BOROUGH OF HIGHLANDS
LAND USE BOARD REGULAR MEETING

AGENDA

6. LUB25-10: Solar Powered 44 – 44 Miller St., B58 L7.01

VARIANCE PLAN

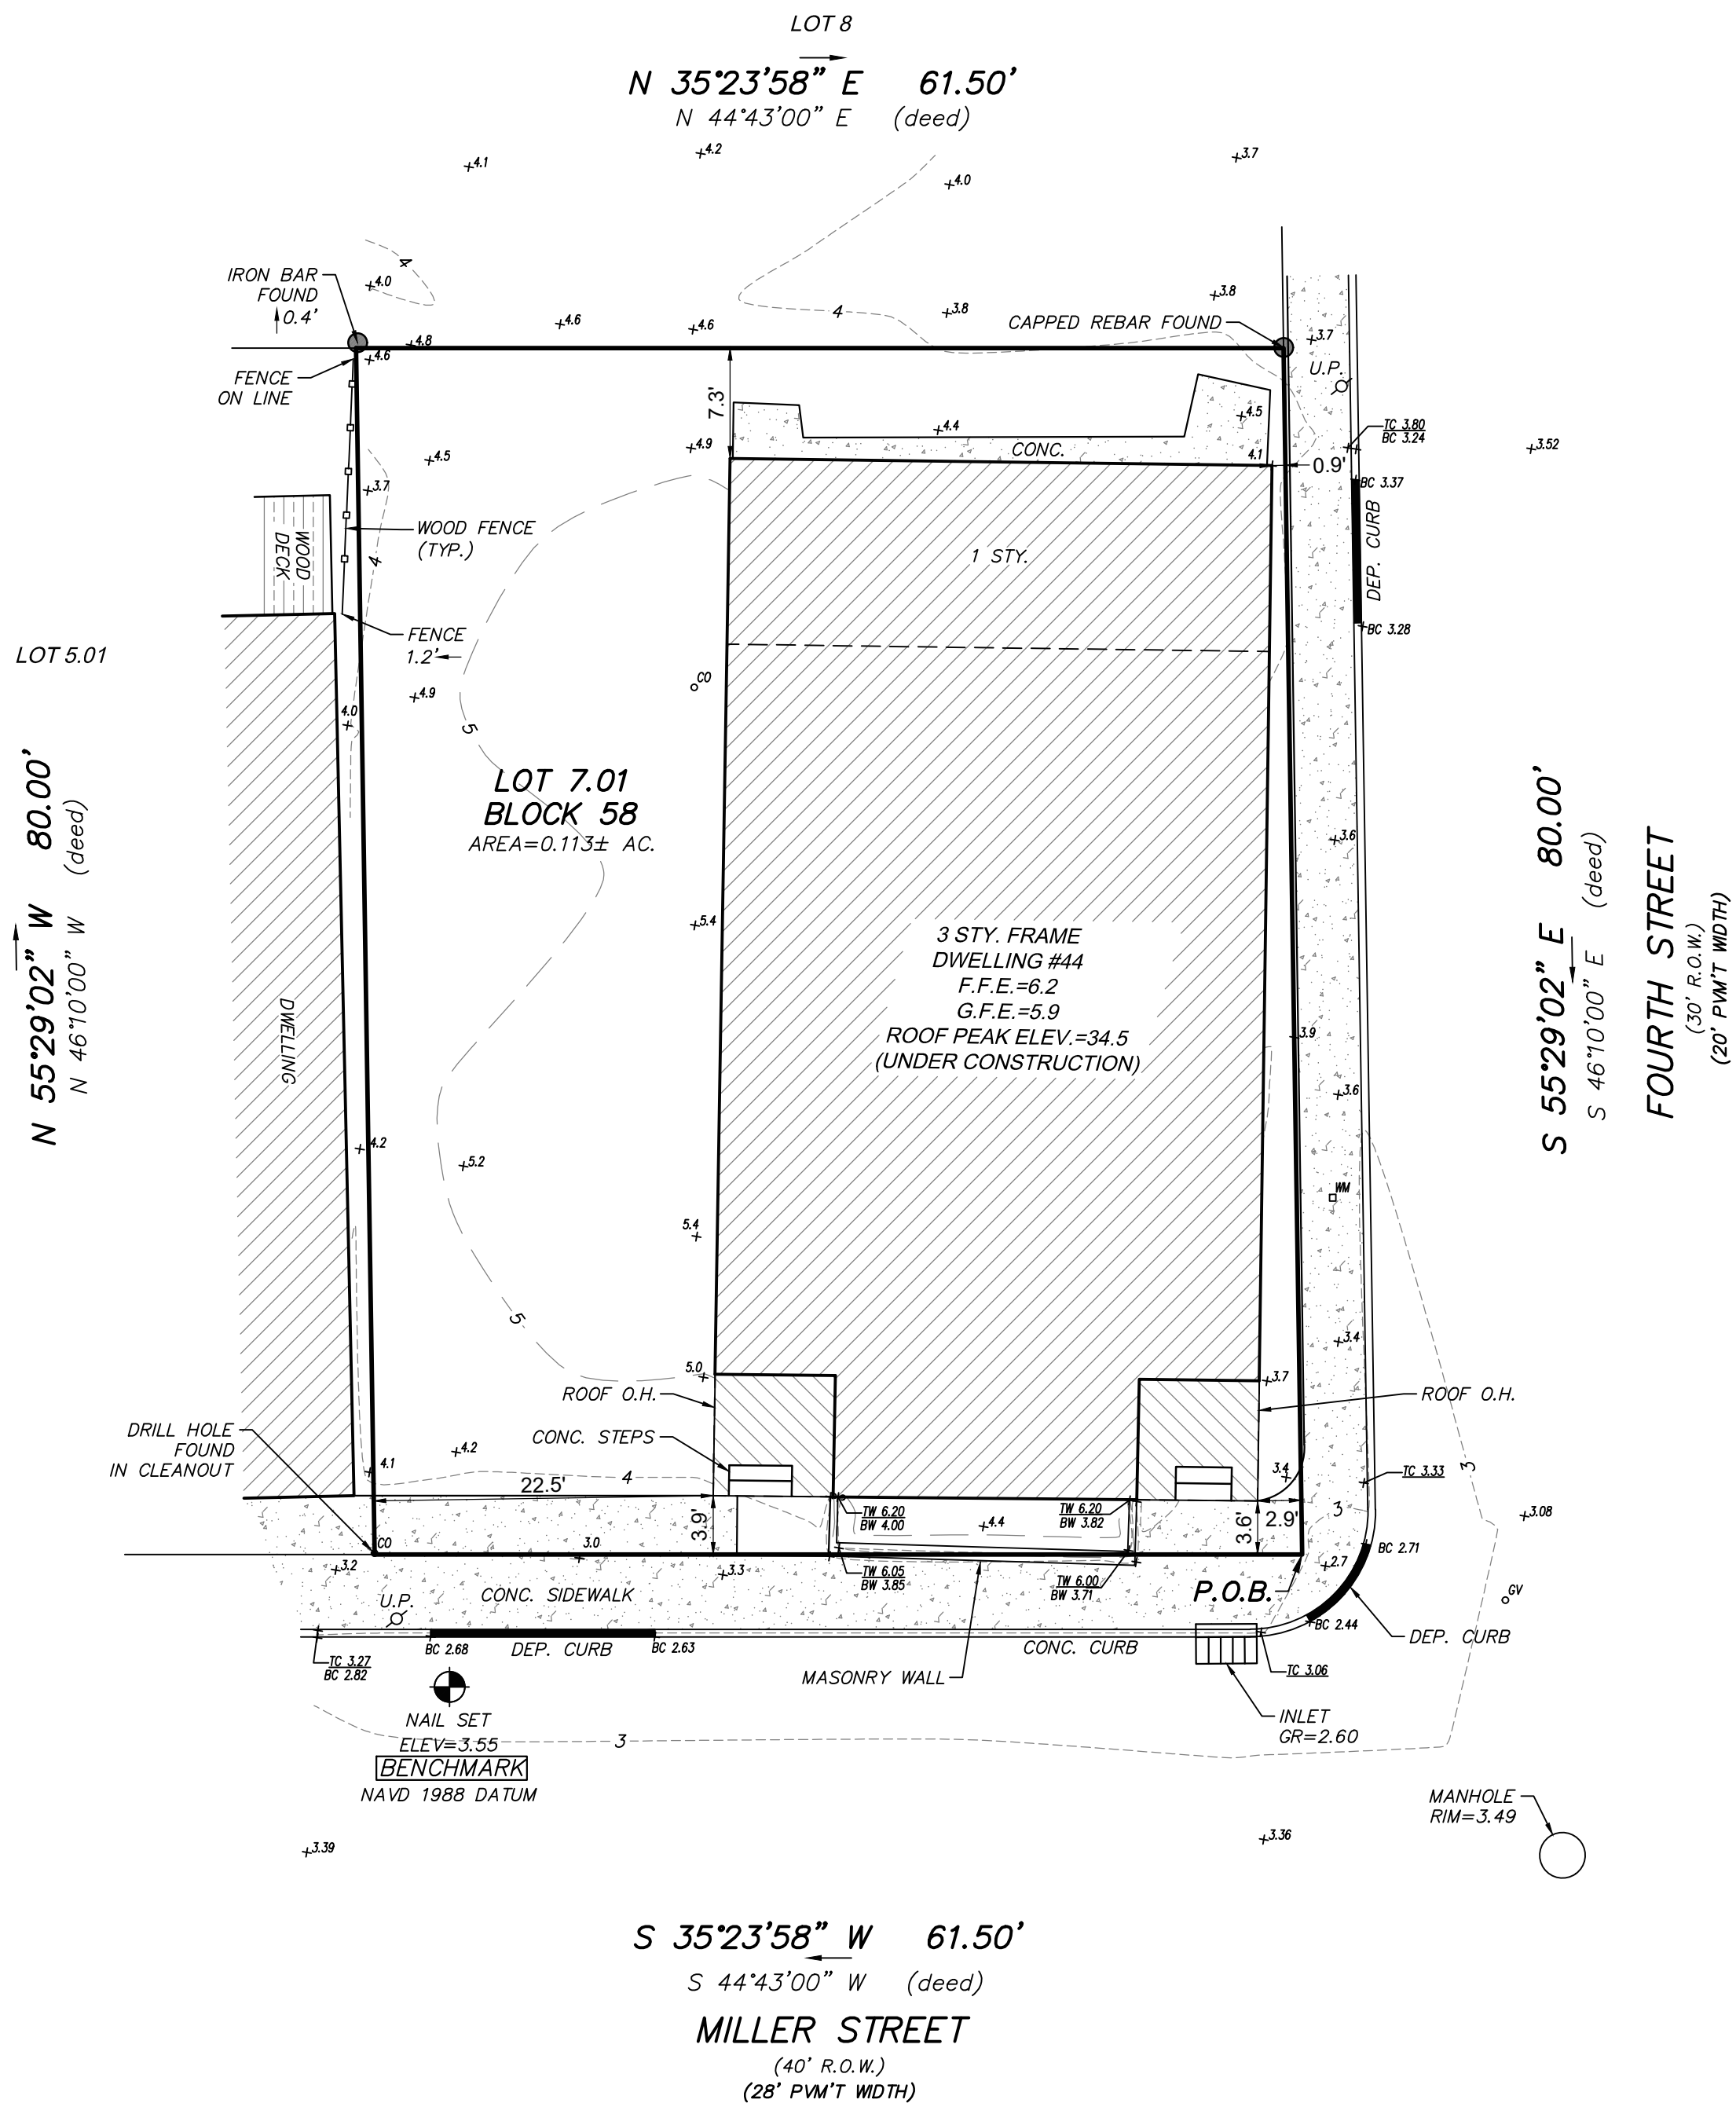
- The location of all existing watercourses, wooded areas, easements, rights-of-way, streets, roads, highways, rivers, buildings, structures, and any other feature on the property and within seventy-five (75) feet of the property line. **Applicant seeks waiver. Acceptable. However, the dwelling and driveway on adjoining Lot 8 need to be shown on the plans.**

Please provide a deck setback category on the zoning table.

A-2

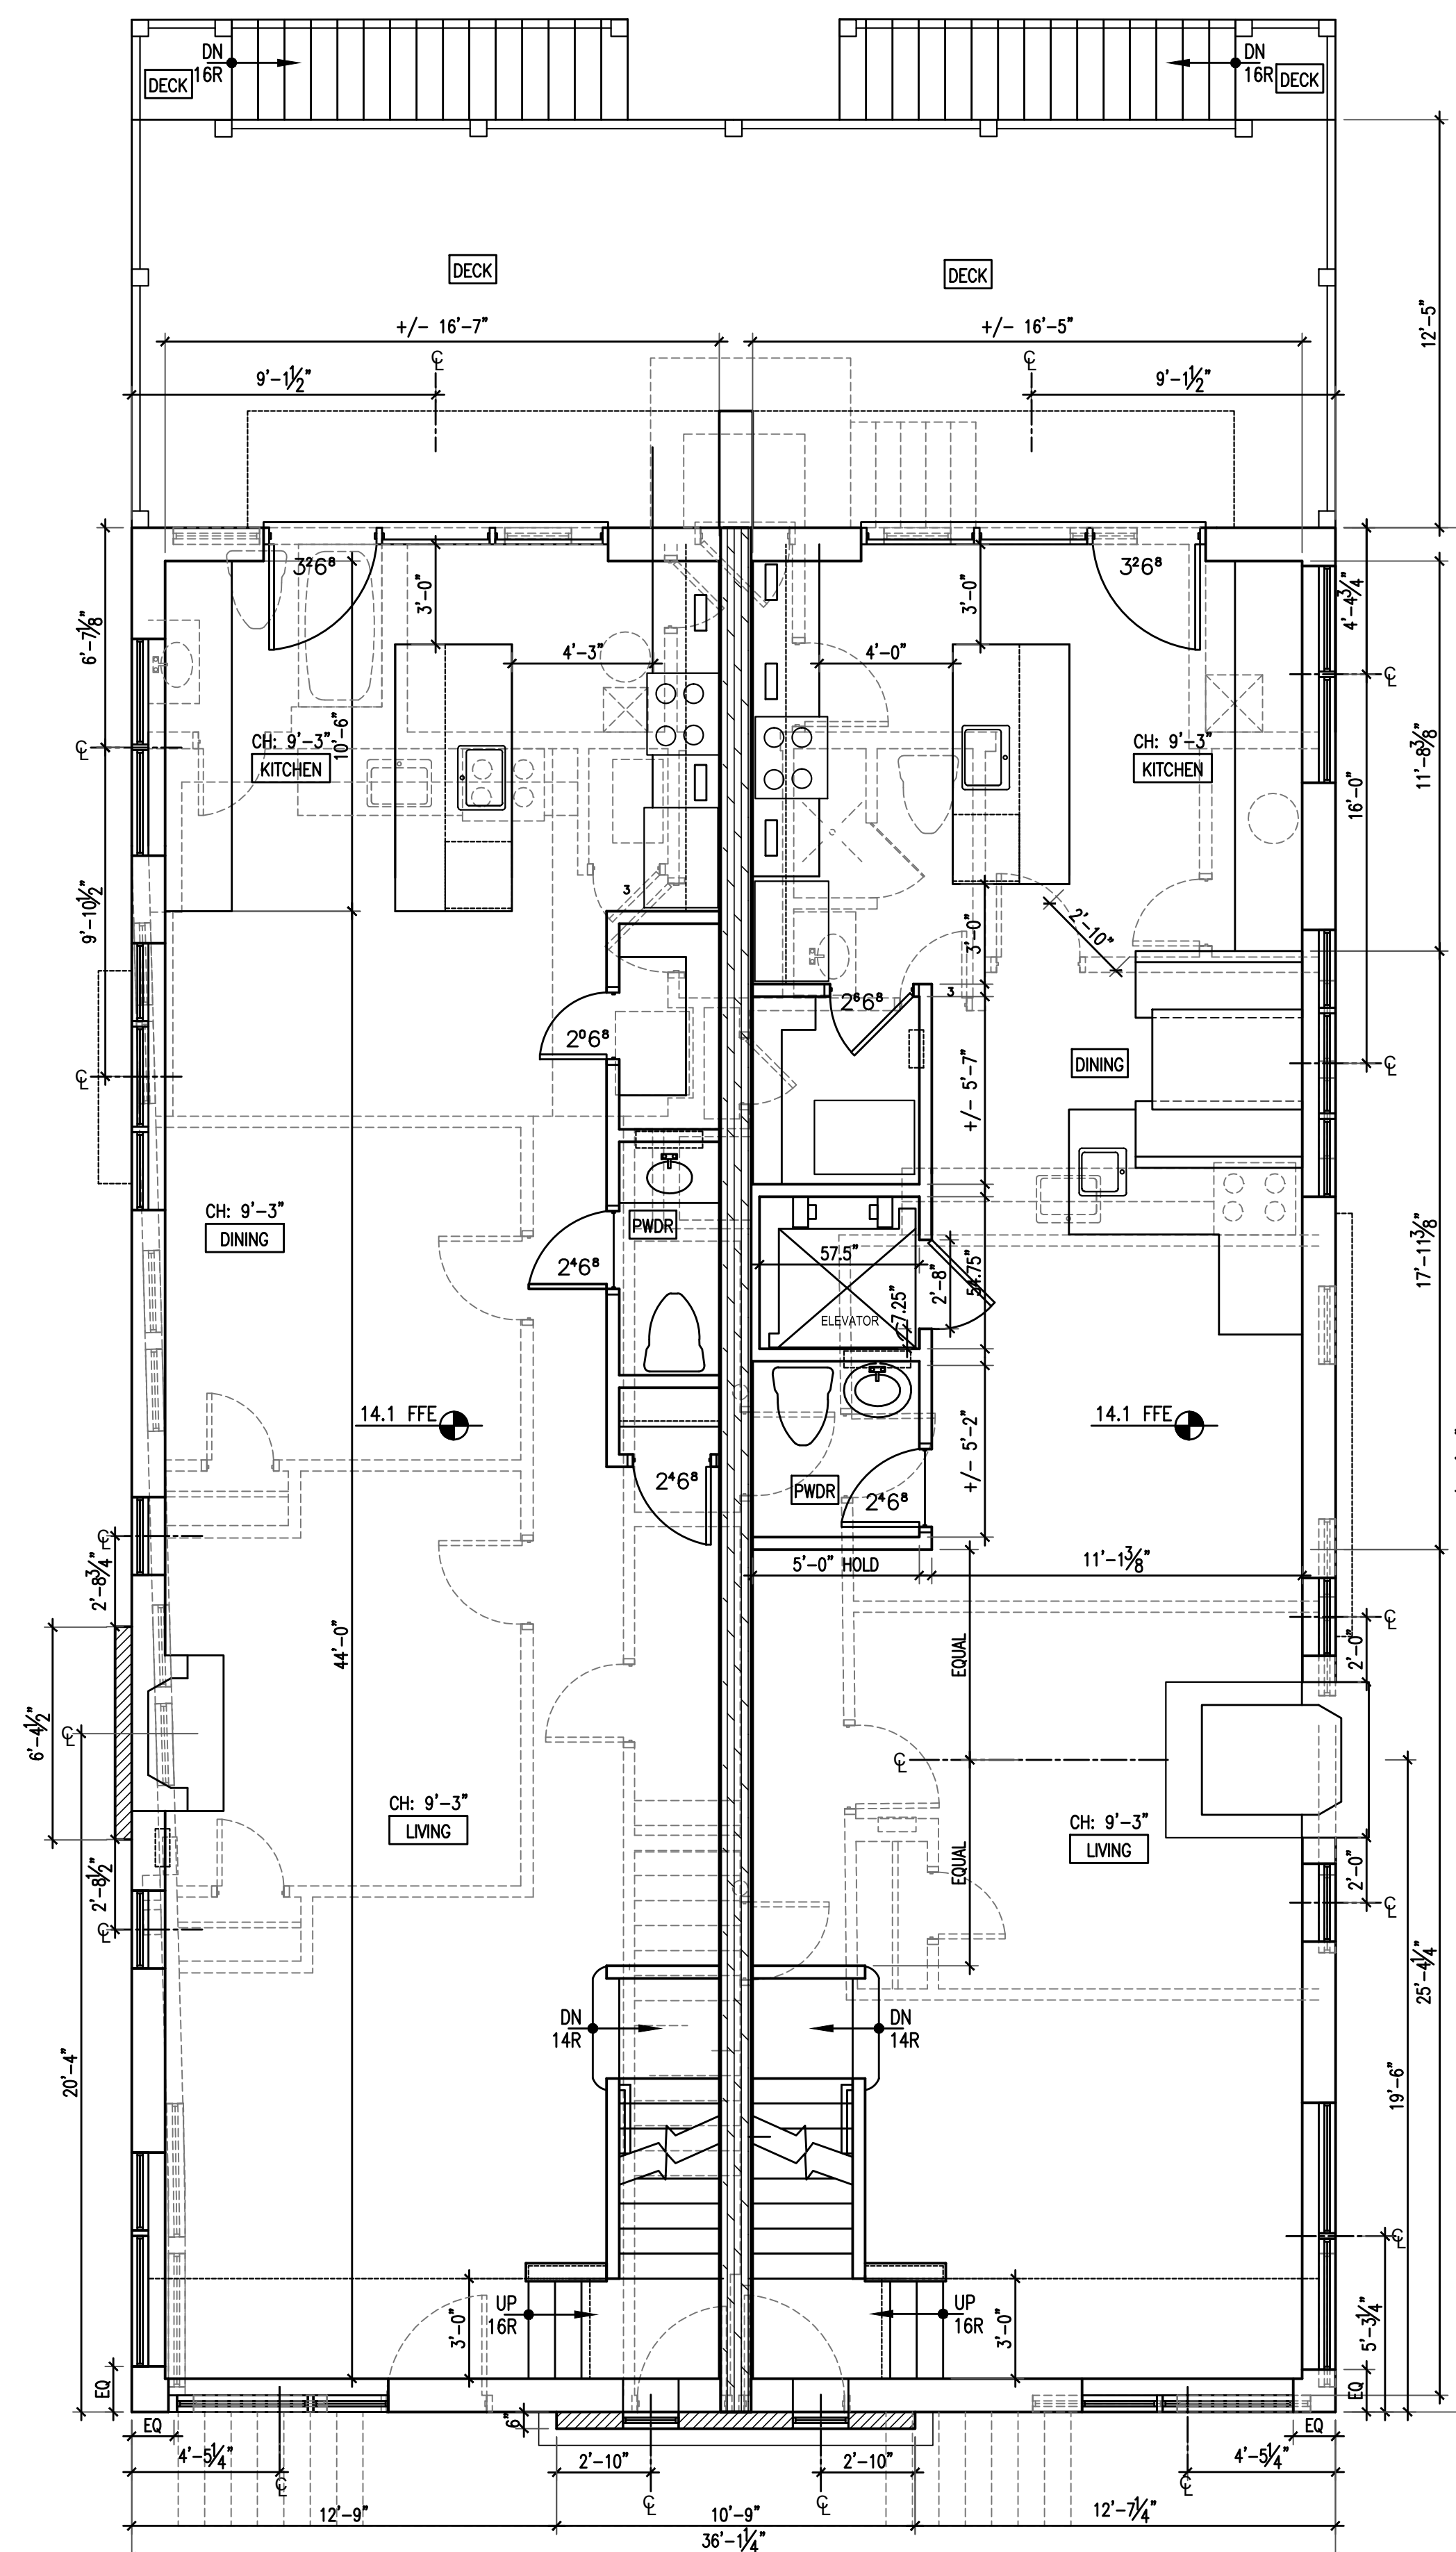
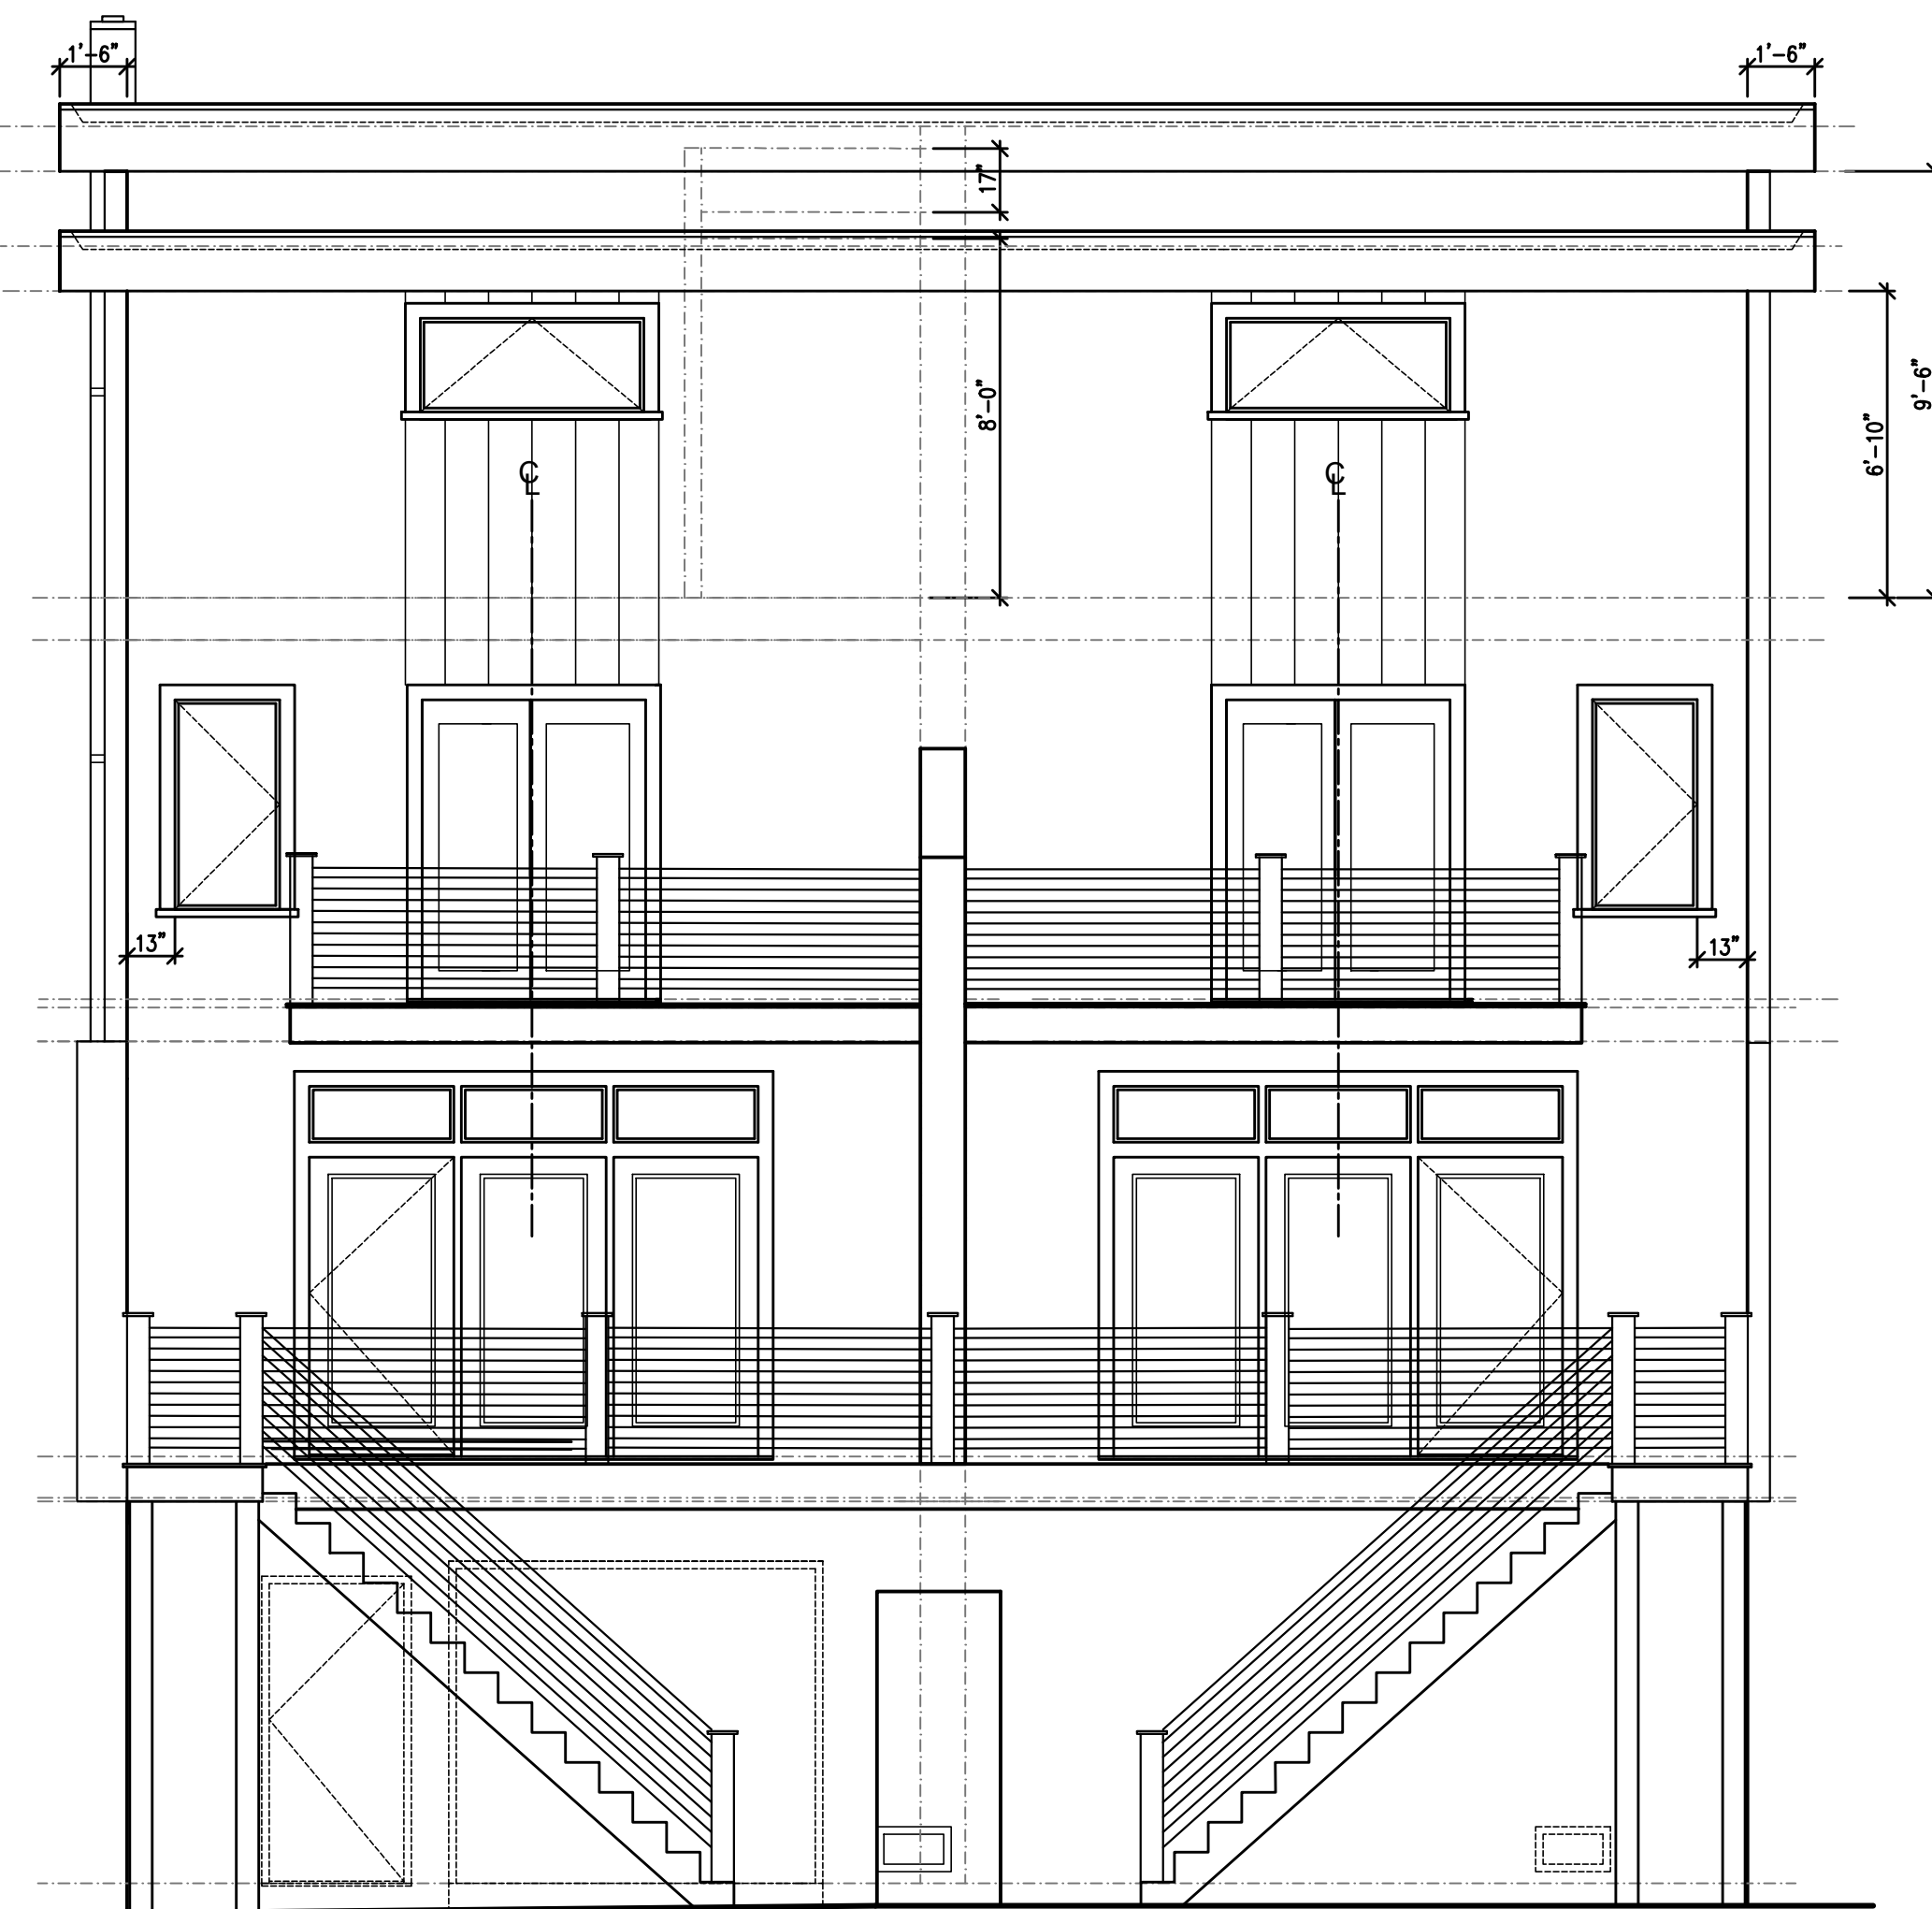
7. The applicant shall clarify whether the existing curb cut along Fourth Street will remain active with the proposed improvements.
 - a. The Foundation Plan on Sheet A-2 describes a fifth garage door leading to an unidentified space at grade level. Is additional parking proposed within this space?
